TI_2221: Tightening torque 3 Nm

All iVario

Tightening torque contactor.

iVario 2-XS, 2-S, 2-S P, L, L P, XL, XL P

Contactor

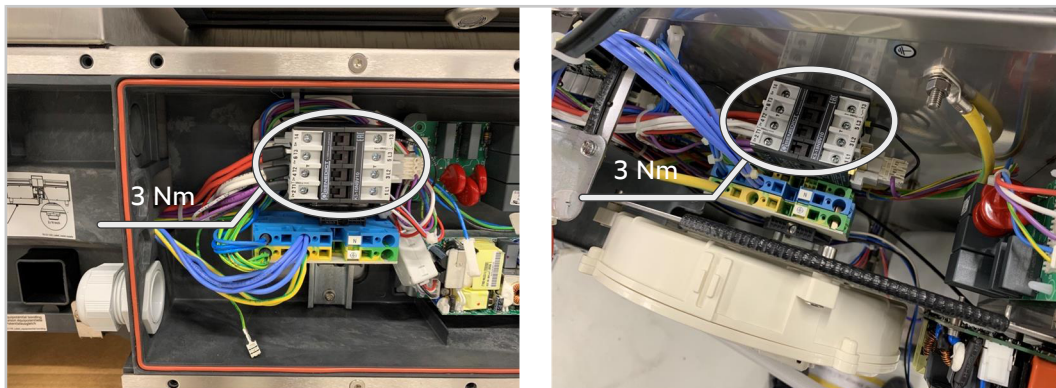
To prevent a fault on the cable crimping and to prevent overheating at the contact points, screw fittings must be tightened to 3 Nm. We would also like to point out that, during the installation of the unit, the input and output screw connection of the contactor must be retightened to 3 Nm.
